# **Lower Thames Crossing**

**Post Event Submissions for Issue Specific Hearings (ISH3 - ISH7) and  
Compulsory Acquisition Hearings (CAH1 & 2)**

**Report Title:** Post Event Submissions for Issue Specific Hearings (ISH3 – ISH7) and  
Compulsory Acquisition Hearings (CAH1 and CAH2)

### Post Hearing Submission made by Thurrock Council including written summary of Thurrock Council’s Oral Case

# Appendix A: Diagram illustrating inter-relationship between modelling and design challenges and concerns

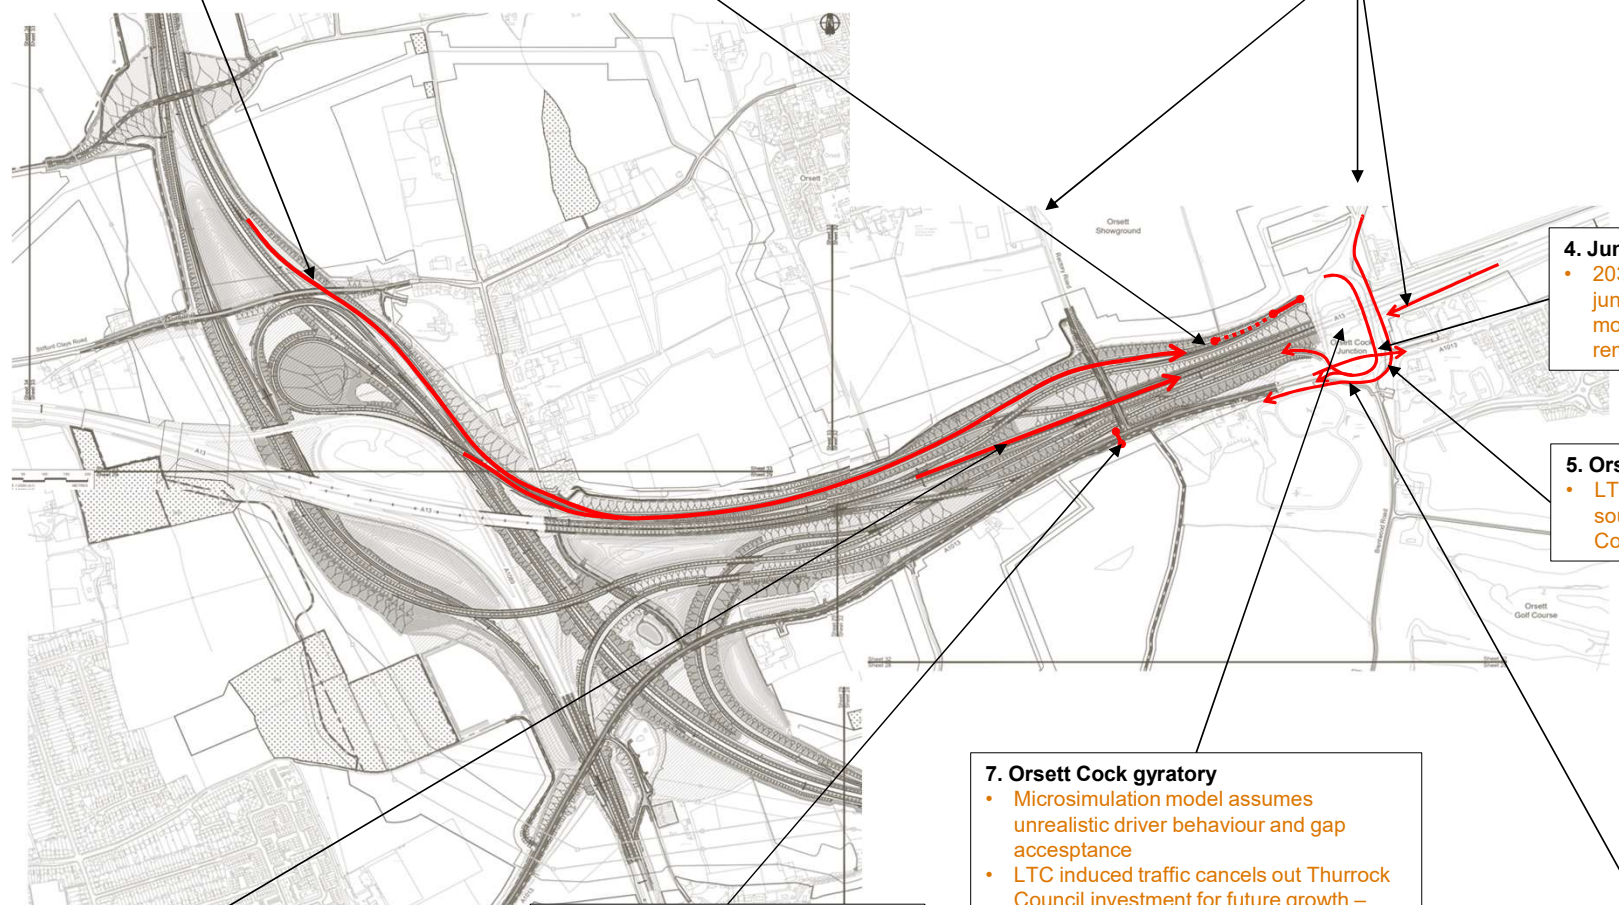
- Peak hour congestion on approach to Orsett Cock, blocking access to A13 eastbound – 2030 and 2045.

- Microsimulation model assumes unrealistic driver behaviour and gap acceptance
- LTC induced traffic cancels out Thurrock Council investment for future growth – contrary to LT scheme objectives
- Current configuration and location not shown in DCO plans
- Submission design ends short of gyratory – no measures proposed

Figure 1 – Option CTL1 LTC plus Tilbury Link Road (retains current proposed LTC/A13/A1089 junction)

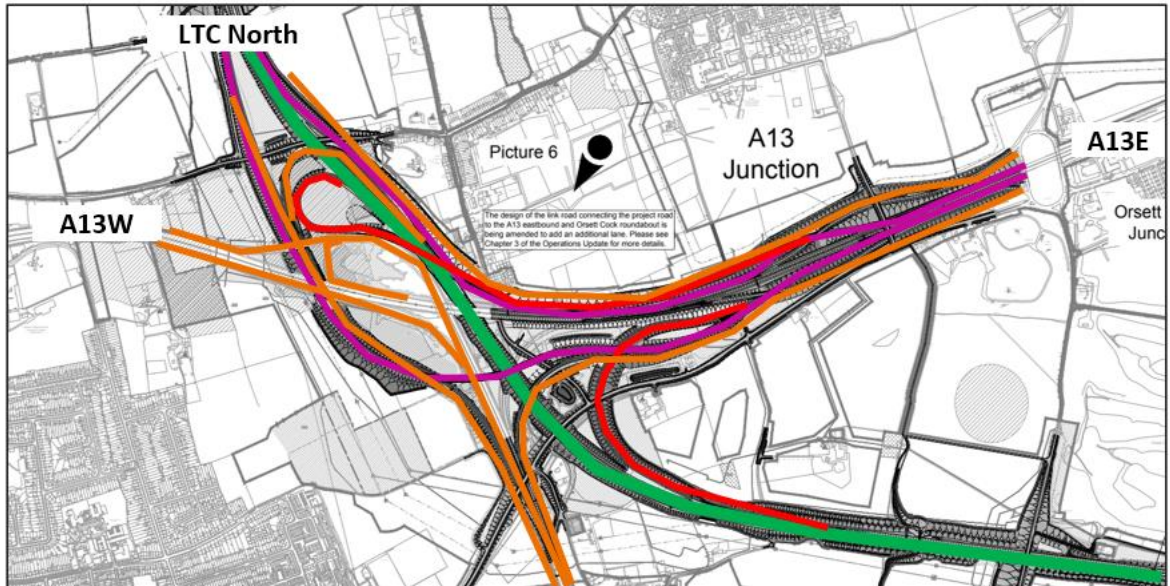
- 3 **Option CTL03** (that adds the TLR and only removes the A1089 links to LTC) to is not likely to provide sufficient further benefits or a large reduction in local harm compared to CTL01. It is not recommended that this option should be assessed further.

Figure 4 – Option CTL5 LTC plus Tilbury Link Road (remove direct A1089 links to LTC and remove A13 east to/from LTC north links)

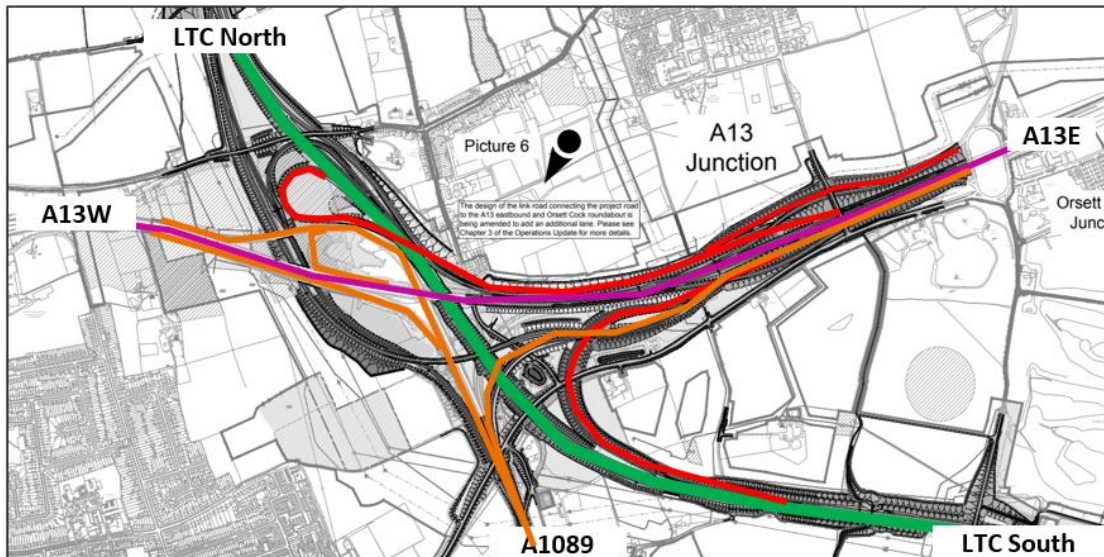
- 4 **Option CTL05** (that includes the TLR and reconfigures the LTC/A13/A1089 interchange to provide no Direct Access to LTC from A1089 or A13 East to/from LTC North) would again enable the physical scale of the LTC/A13 interchange and its associated local environmental impacts and harm in Thurrock to be significantly reduced whilst still providing strategic road network benefits at the Dartford Crossings, M25 approaches and A13 Corridor (west of LTC). CTL05 is forecast to significantly reduces traffic demand on A1089 and at Asda Roundabout, that alongside the benefits of the TLR, would provide more local movement capacity and connectivity to support growth in the Tilbury area and at the Port of Tilbury. Supporting improvements could be required at the M25 J30, A1089 Asda Roundabout, Orsett Cock and The Manorway (as with the LTC scheme).

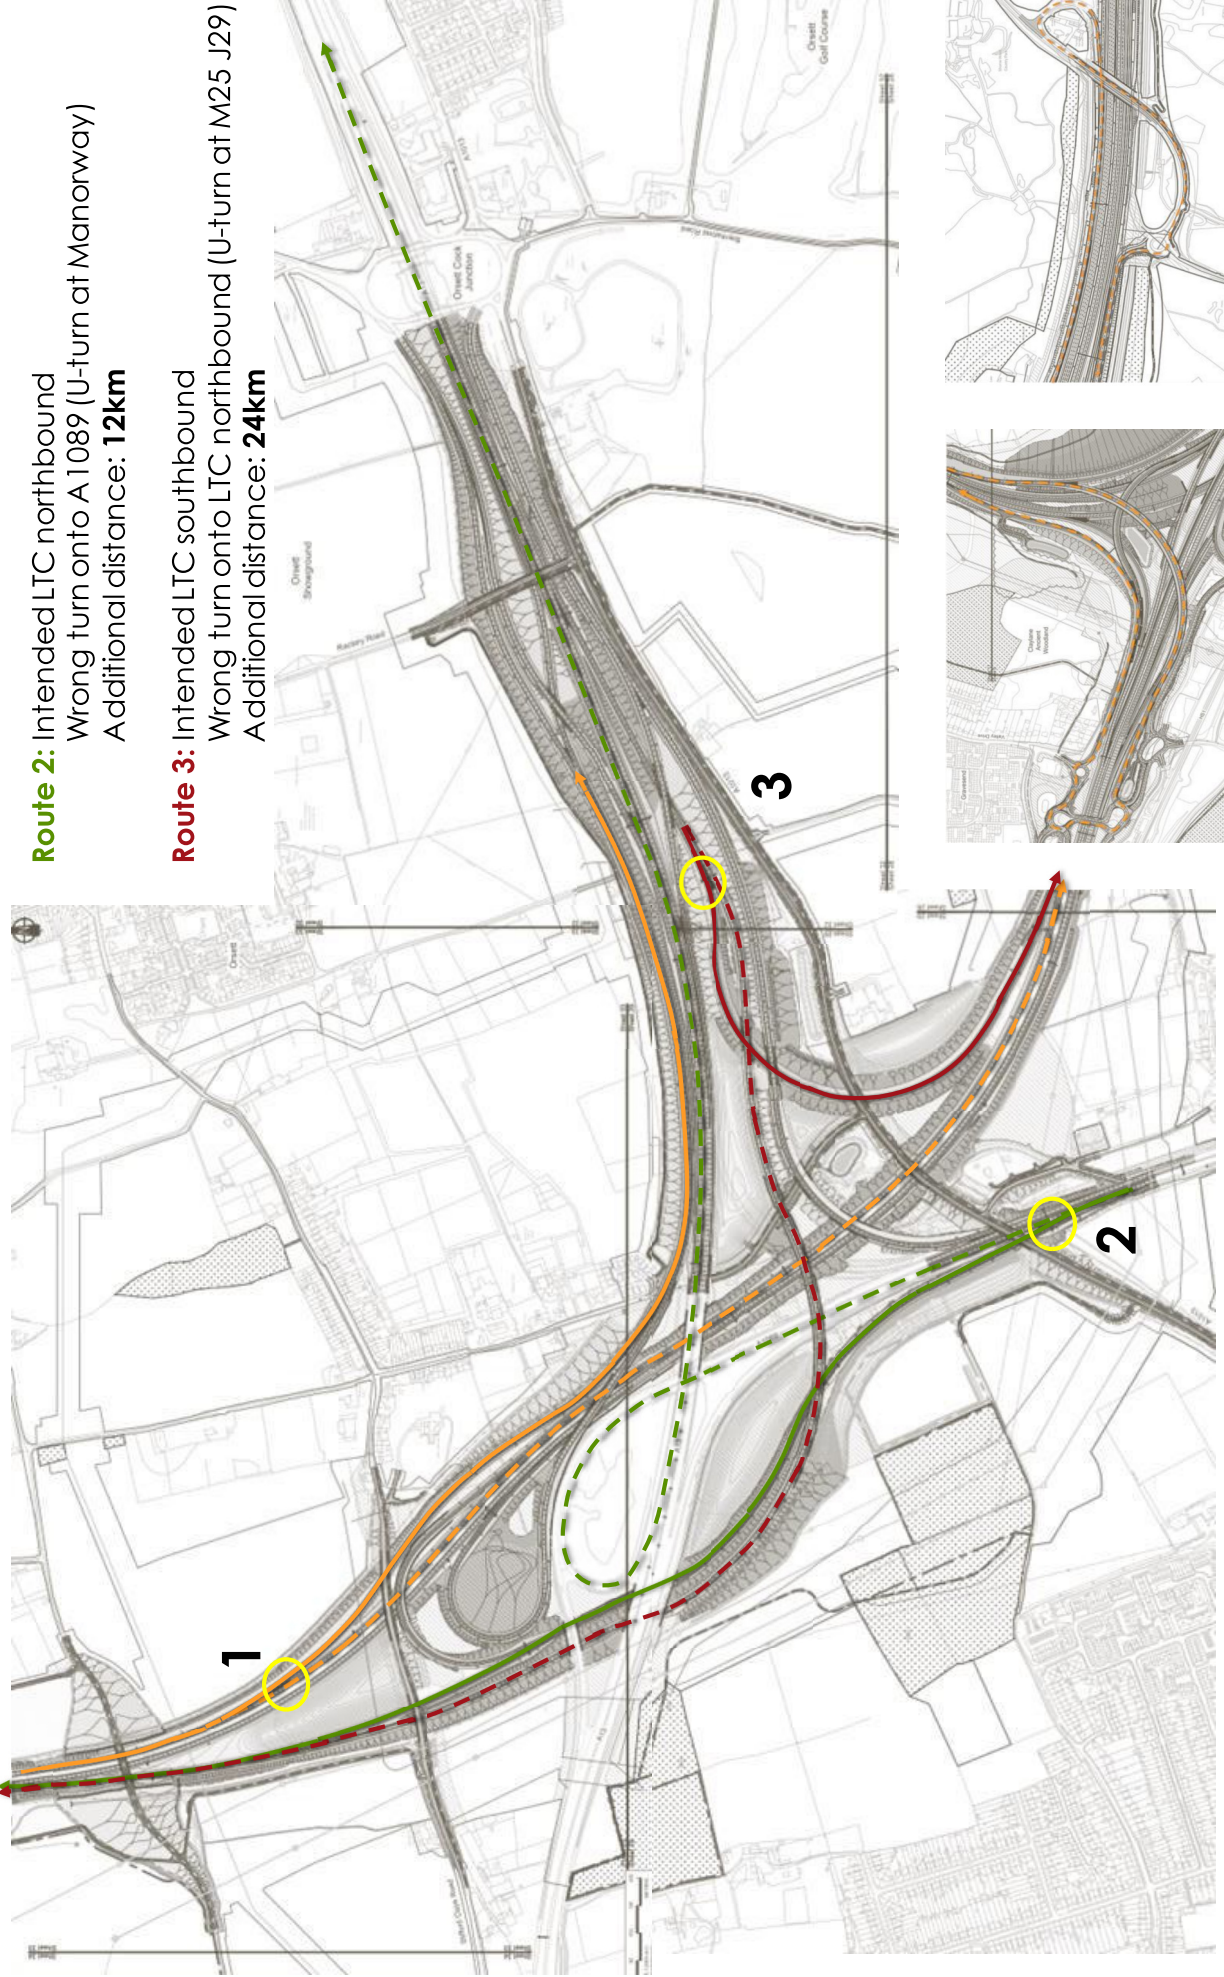
**Route 1:** Intended A13 eastbound  
 Wrong turn onto LTC southbound (U-turn at A2/M2/LTC junction or A2/Brewers Road junction)  
 Additional distance: **30km or 31km** respectively

**Route 2:** Intended LTC northbound  
 Wrong turn onto A1089 (U-turn at Manorway)  
 Additional distance: **12km**

**Route 3:** Intended LTC southbound  
 Wrong turn onto LTC northbound (U-turn at M25 J29)  
 Additional distance: **24km**
